**CITY OF MISSOURI CITY  
PLANNING AND ZONING COMMISSION AGENDA**

**SUBJECT:** Sienna Village of Destrehan Section 6B - Preliminary Plat

**SUBJECT:** Sienna Village of Destrehan Section 7B - Preliminary Plat

PRELIMINARY PLAT  
SIENNA  
VILLAGE OF DESTREHAN  
SECTION 6B

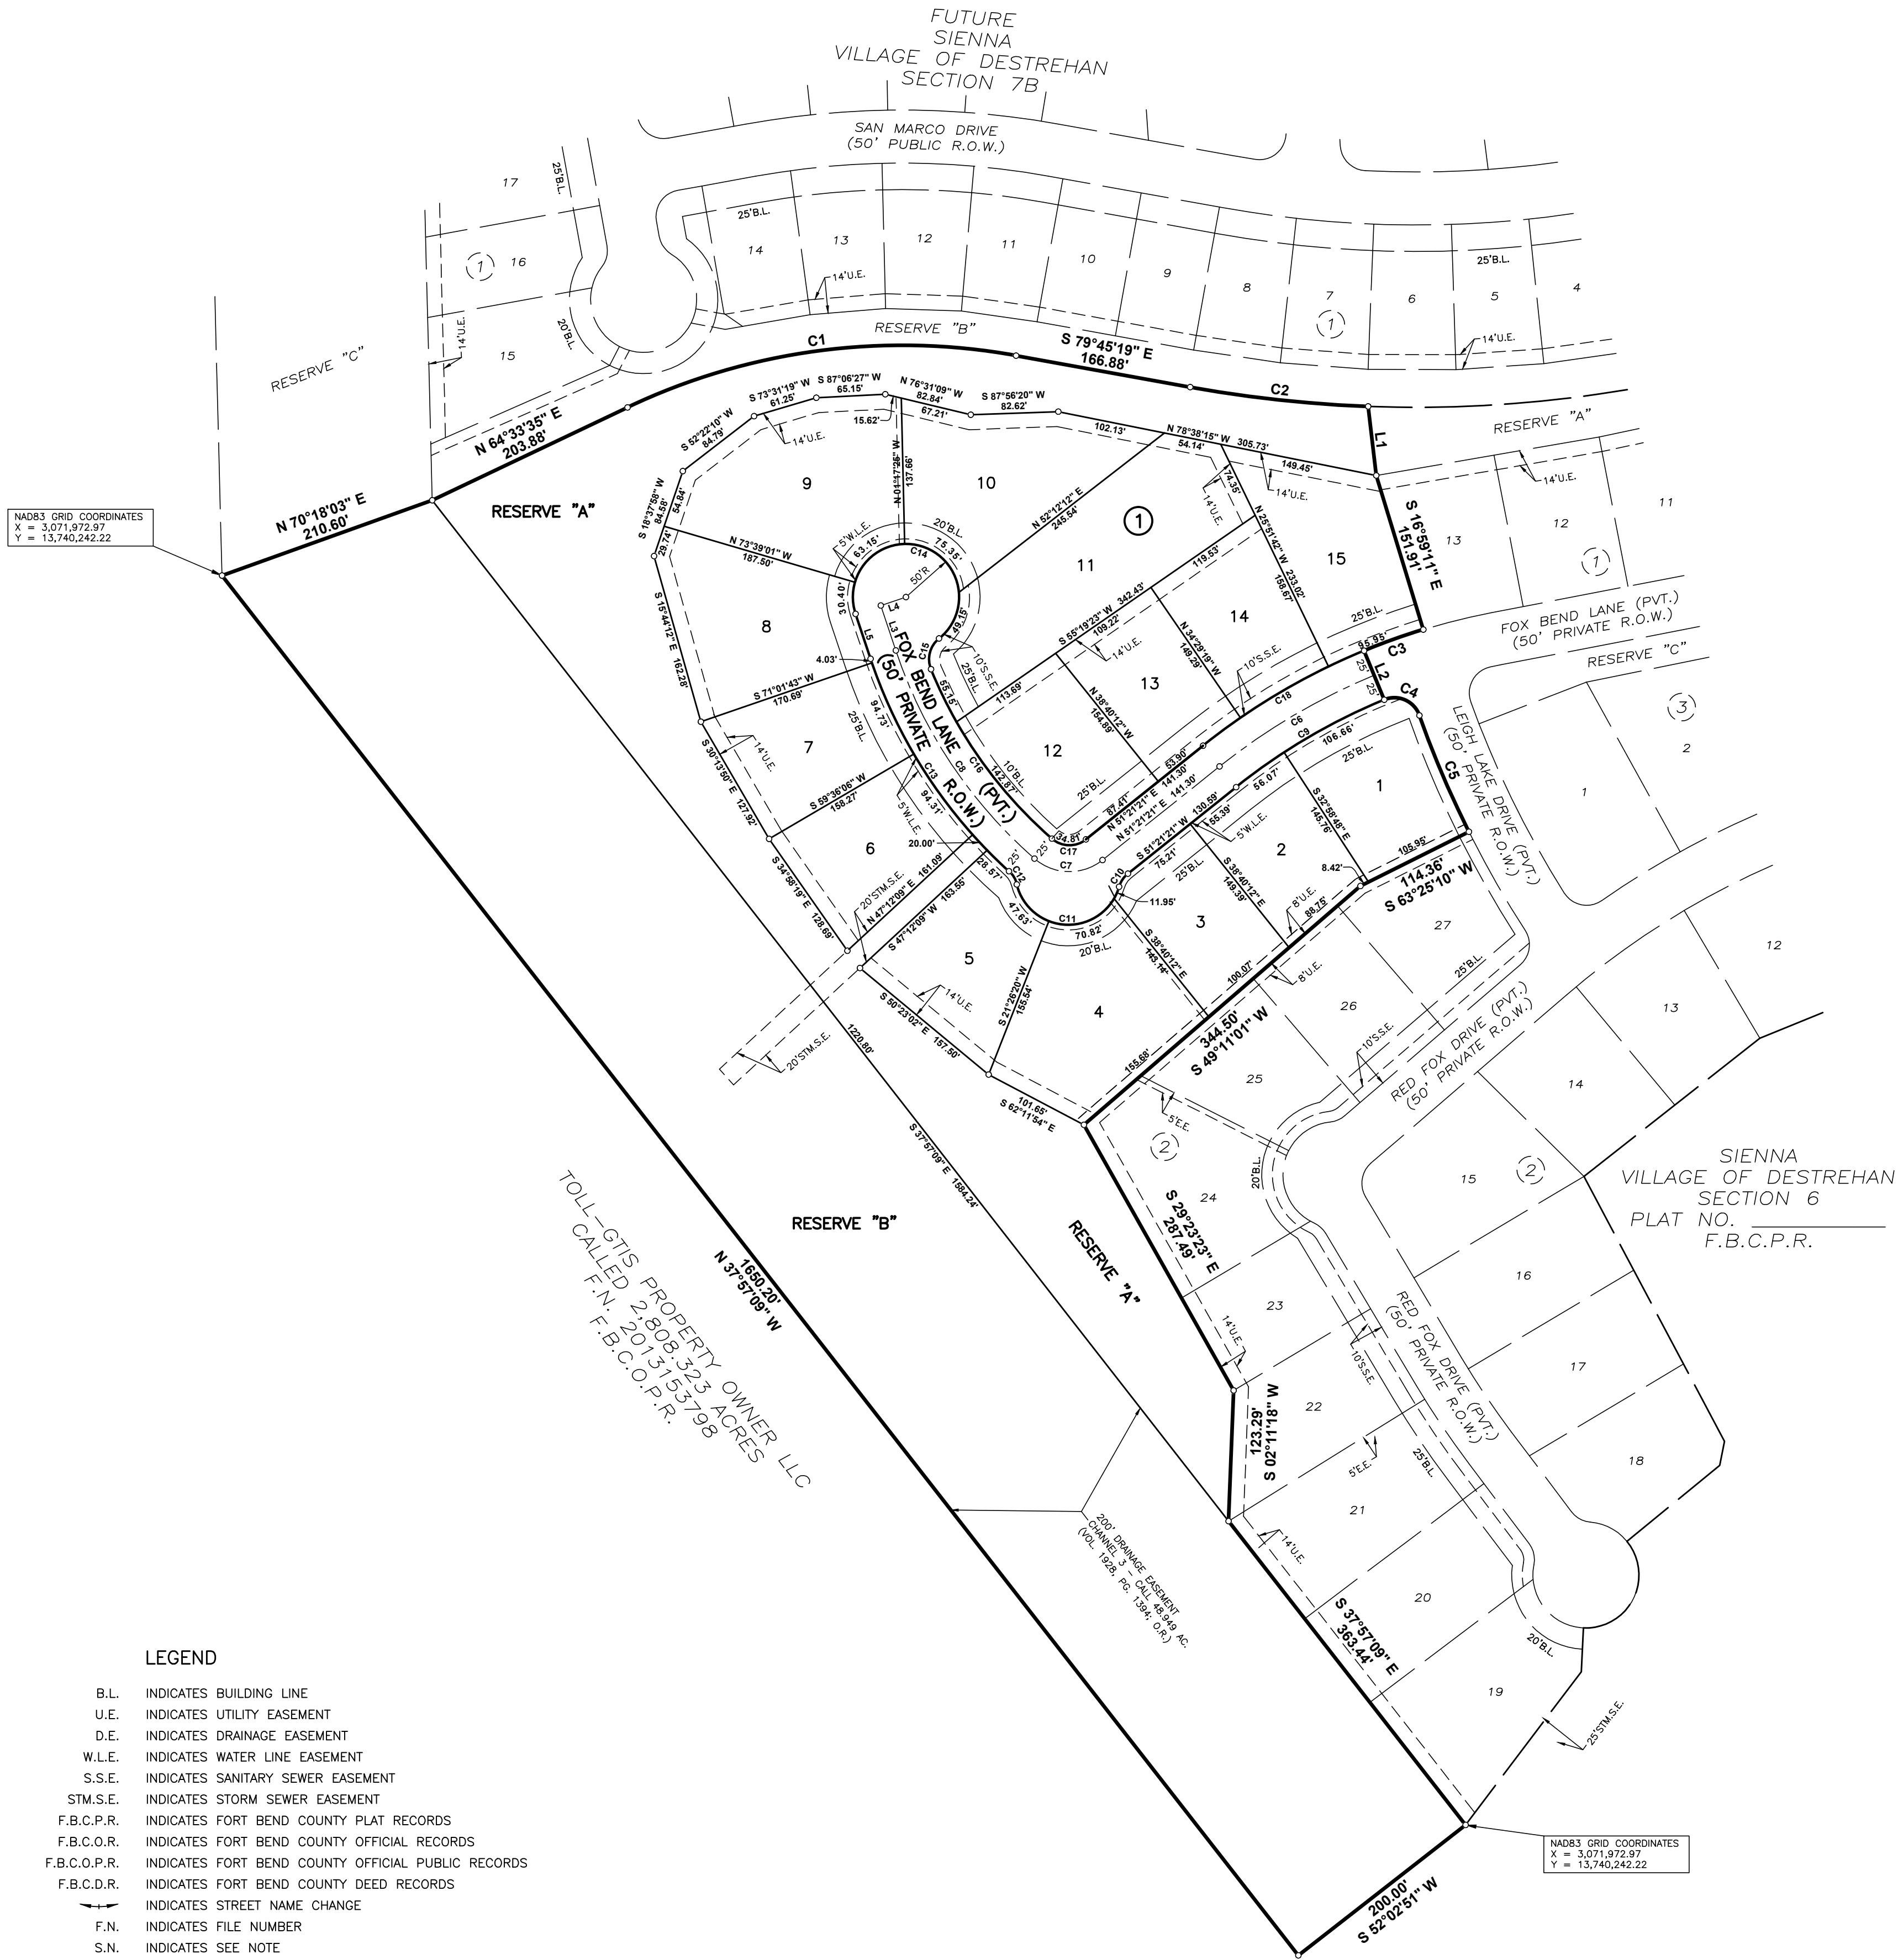
1. All conditions placed on the approval of Sienna Plantation Phase 1B, Sections 6B, 7B, 9B, 10 -13B – Conceptual Plan must be approved.
2. The point of beginning (POB) for the subdivision shall be expressed as Texas State Plane NAD83 grid coordinate values of "X", "Y" as required by the City of Missouri City Design Manual, Section 2.10(G). **Please indicate POB on the plat.**
3. A temporary benchmark (TBM) shall be set in the subdivision in accordance with Section 2.D(15). The basis of control for the TBM shall also be indicated.
4. A preliminary utility plan with calculations must be provided in accordance with Section 2.D(19). **Utility models for water and sanitary are required per Chapter 5.02 and 6.02 of the City's Public Infrastructure Manual. Additionally, provide information on minimum fire flow and minimum system pressure.**

1. An electronic plat shall be submitted in accordance with Section 2.D(2). **Please provide a DWG file of the plat that is projected correctly.**
2. All lots and blocks shall be numbered or lettered consecutively in accordance with Section 2.D(3). A table should be used listing the identifying letter, use, and acreage of all reserves. **Please revise reserve table to indicate accurate ownership and use for proposed Reserve B.**

3. The location, rights-of-way widths, and names of all **existing and proposed easements**, including pipeline, within or adjacent to the subdivision for a distance of not less than 200 feet shall be indicated in accordance with Section 2.D(12). **Please indicate all easements within 200 feet of the proposed subdivision including the easement abutting lot 19 of Sienna Village of Destrehan Section 6 and the extension of 200 feet drainage easement outside the proposed plat boundary.**

5. Building lines shall be labeled in accordance with Section 2.D(17). **Please indicate side building line for Lot 1 of the proposed subdivision.**
6. Update provided copy of restrictive covenants to provide a description of the subject property. A notice of applicability as referenced in the document should be provided with a final plat application and upon recordation of the covenants.

PRELIMINARY PLAT  
SIENNA  
VILLAGE OF DESTREHAN  
SECTION 7B

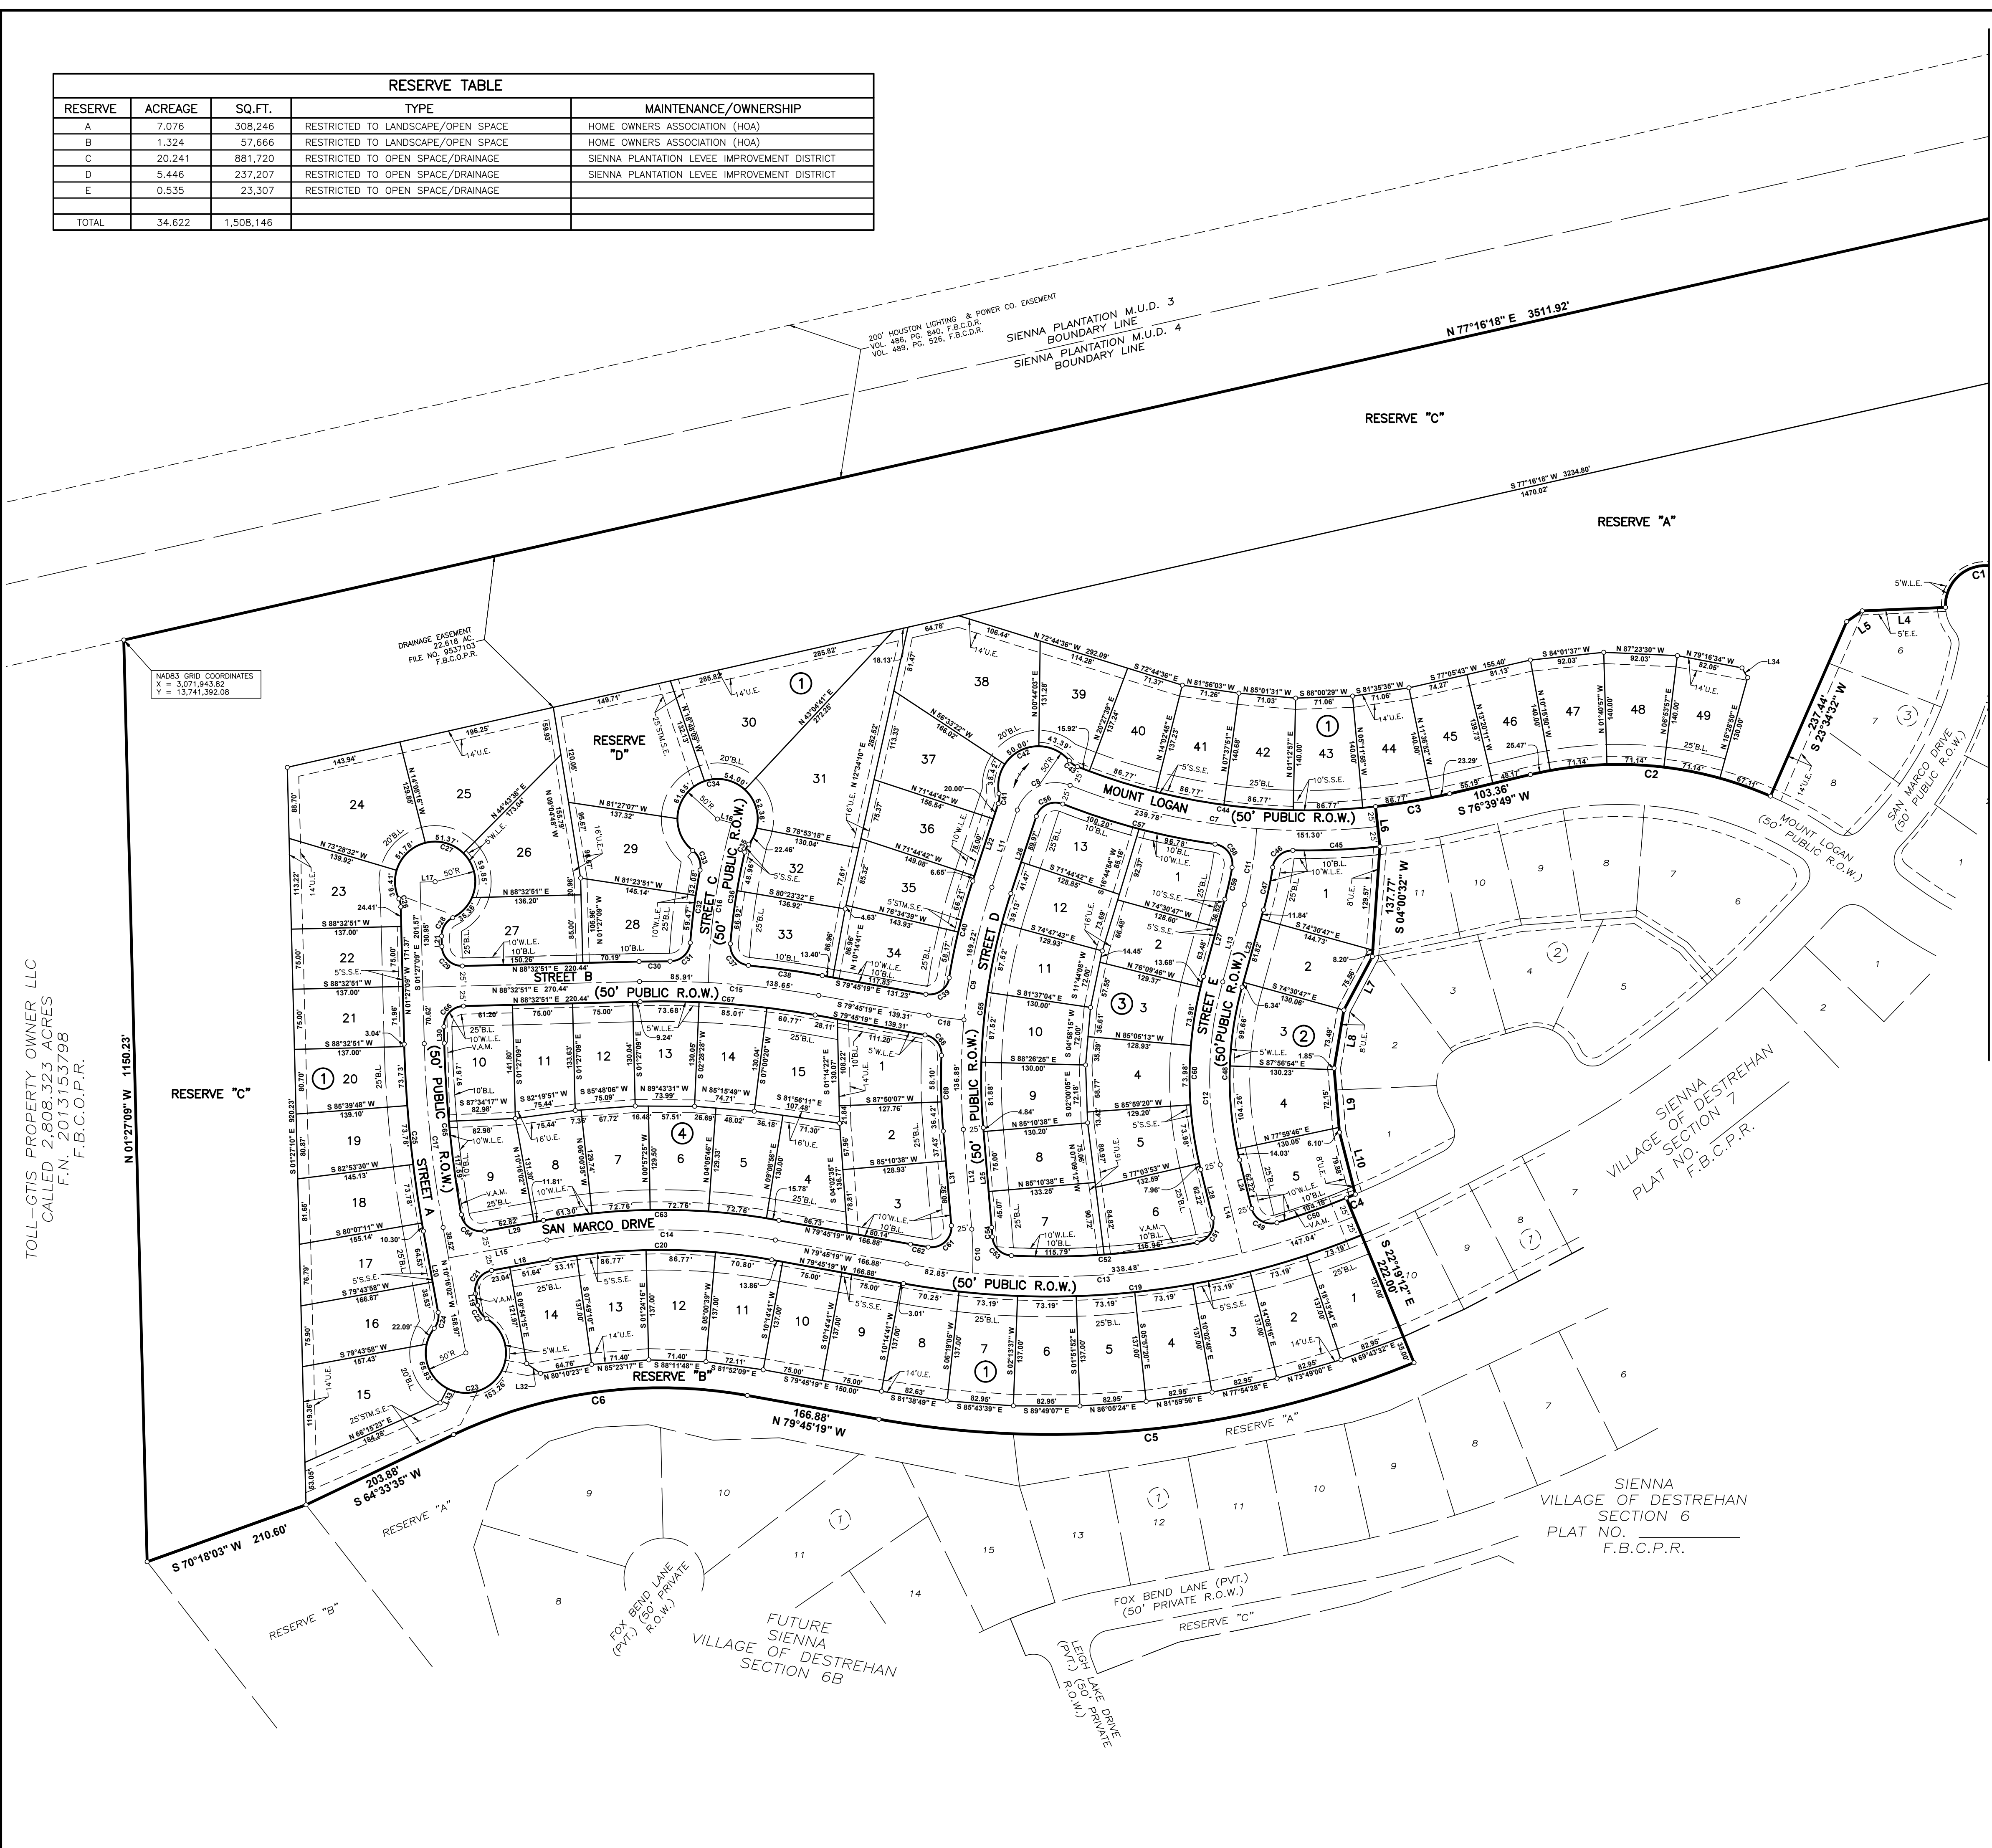
1. All conditions placed on the approval of Sienna Plantation Phase 1B, Sections 6B, 7B, 9B, 10 -13B – Conceptual Plan must be approved.
2. The point of beginning (POB) for the subdivision shall be expressed as Texas State Plane NAD83 grid coordinate values of “X”, “Y” as required by the City of Missouri City Design Manual, Section 2.10(G). **Please indicate POB on the plat.**
3. A temporary benchmark (TBM) shall be set in the subdivision in accordance with Section 2.D(15). The basis of control for the TBM shall also be indicated.
4. A preliminary utility plan with calculations must be provided in accordance with Section 2.D(19). **Utility models for water and sanitary are required per Chapter 5.02 and 6.02 of the City’s Public Infrastructure Manual. Additionally, provide information on minimum fire flow and minimum system pressure.**

1. An electronic plat shall be submitted in accordance with Section 2.D(2). **Please provide a DWG file of the plat that is projected correctly.**
2. The total number of acres, lots, blocks, AND reserves shall be indicated in accordance with Section 2.D(3). **The proposed number of lots indicated on the application, title block, preliminary plat, and the conditionally approved conceptual plan do not match. Please provide proposed number of lots for this subdivision.**

3. All lots and blocks shall be numbered or lettered consecutively in accordance with Section 2.D(3). A table should be used listing the identifying letter, use, and acreage of all reserves. **Please revise reserve table to indicate accurate ownership and use for all proposed Reserves.**

4. The location, rights-of-way widths, and names of all **existing** and **proposed easements**, including pipeline, within or adjacent to the subdivision for a distance of not less than 200 feet shall be indicated in accordance with Section 2.D(12). **Please indicate all easements within 200 feet of the proposed subdivision.**

6. An alphabetical list of proposed street names for the subdivision shall be provided in accordance with Section 2.D(23). Street A, B, C... are not valid street names. **Please propose valid street names and provide a revised alphabetical list of streets.**
